NUCLEAR REGULATORY COMMISSION
REGION I
475 ALLENDALE RD.
KING OF PRUSSIA, PA 19406-1415

RESPONSE TO CONTROL #129009

RE: License Renewal
Control #129009

LABORATORY FACILITIES/FLOOR PLAN

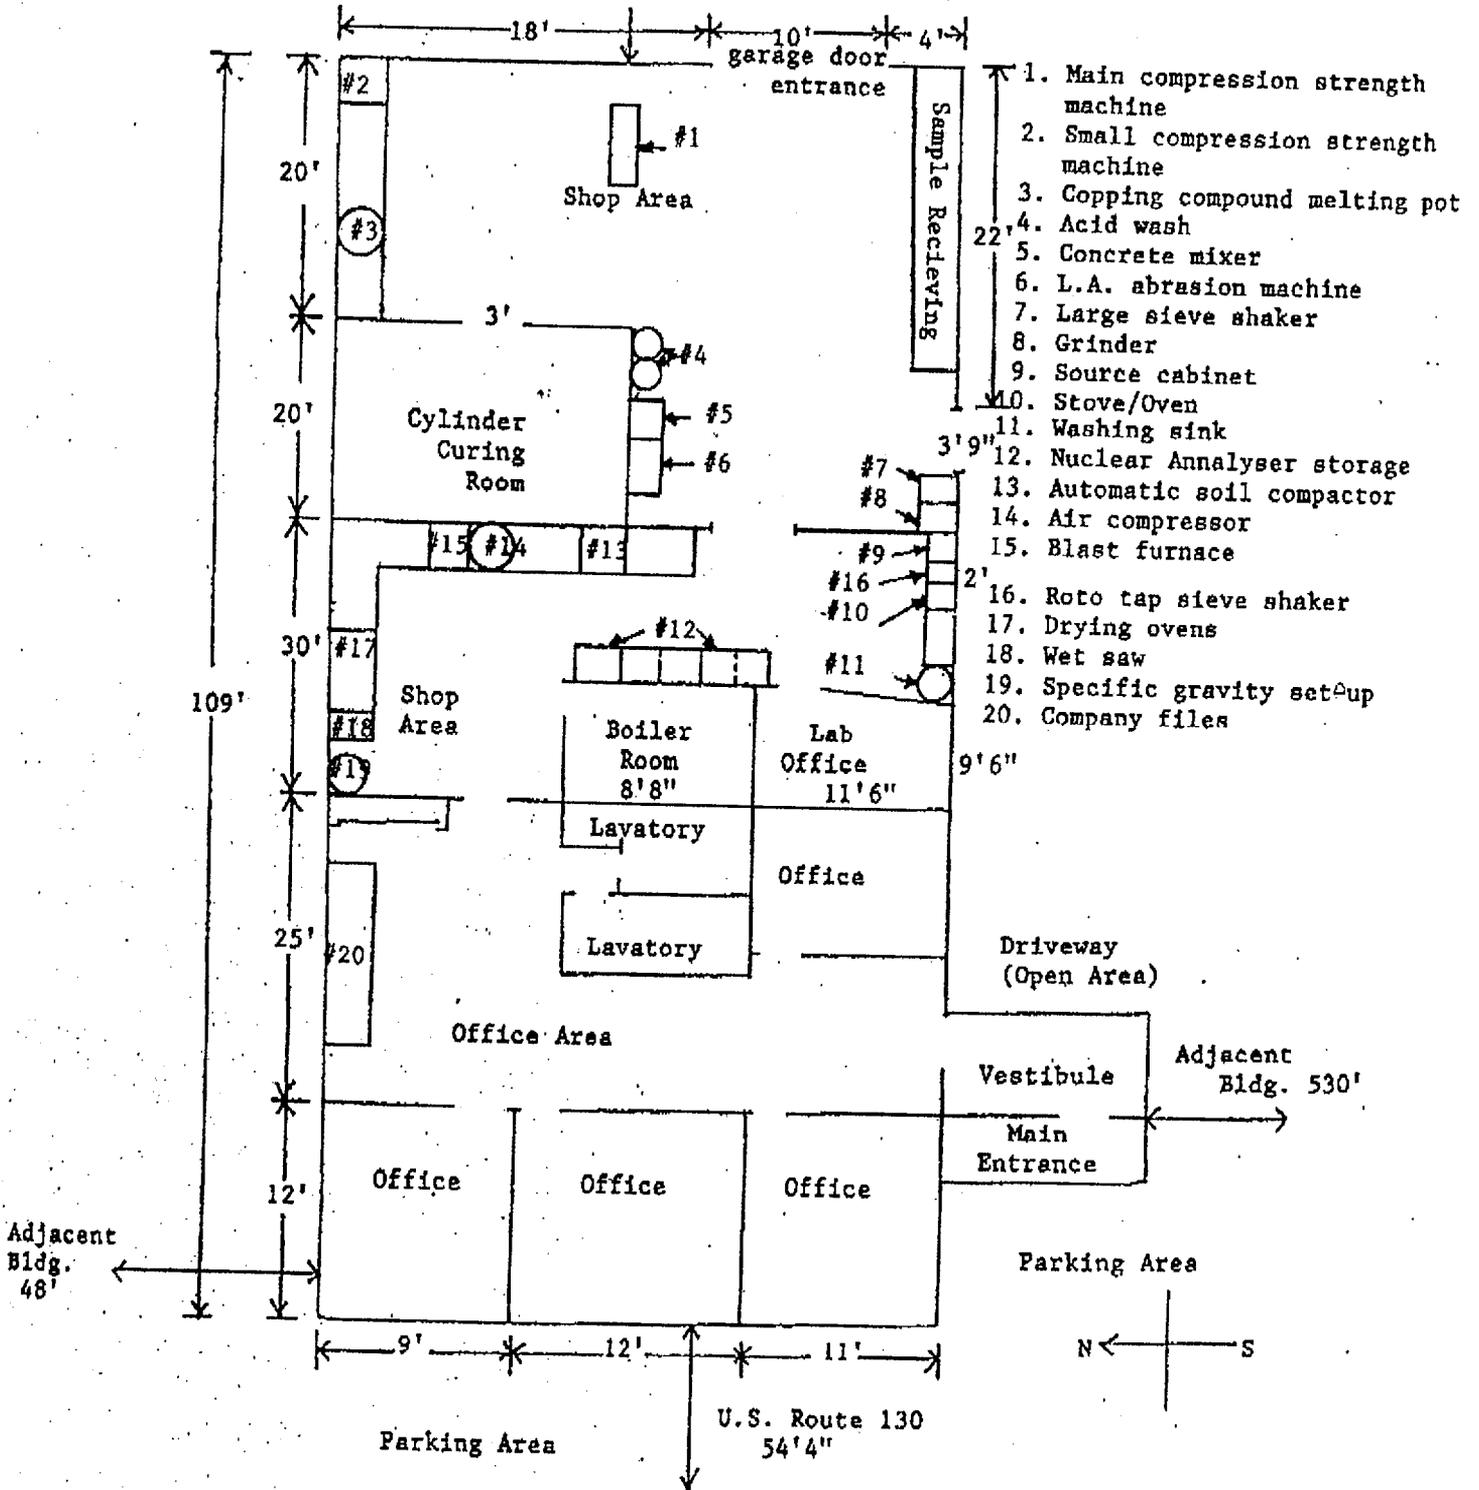
1. At this time, Certified Testing will not perform calibrations of Survey Instruments. All calibrations will be performed by NRC License Companies.
2. Storage of Sources at our Bordentown office are located in the back office in a locked storage cabinet. Dimensions are 5' x 10' H x 31"D x 2'7" W. The door is sheeted with 1/16" lead sheets. The back of storage is a concrete block wall. See attached diagram.
